**Flood Control Project Maintenance
Levee Inspections**

Maintenance Issue Types Only, Levee Inspection Report By Mile - Fall 2018

Reclamation District No. 0070 Meridian

Photo 2 of 3 : LEVAL_FA_2018_154_1687.jpg

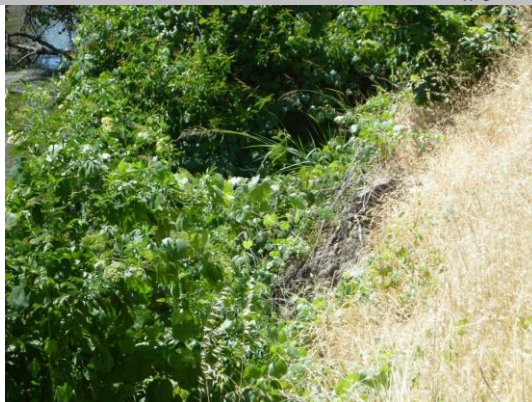
LM Start	0.76	Rating **	A/W	Issue No.	36 (cont)	
LM End	0.76	Issue Type +	Ma	Location *		
Category	Supplemental			GPS Latitude/Longitude		
				Start	End	
Item	2017 Storm Damage			39.145240 °	39.145240 °	
				-121.842650 °	-121.842650 °	
DWR ID	DWR_RD0070_01_f_2017_36					
Comment Code						
Inspector Comment						
Levee Evaluation Comments						
Description:						
Site ID No:154						
Site Designation:RD 70-03						
Repair Type: Erosion						
Rating:Area of Concern						
Field Date:7/17/2017						
Notes:
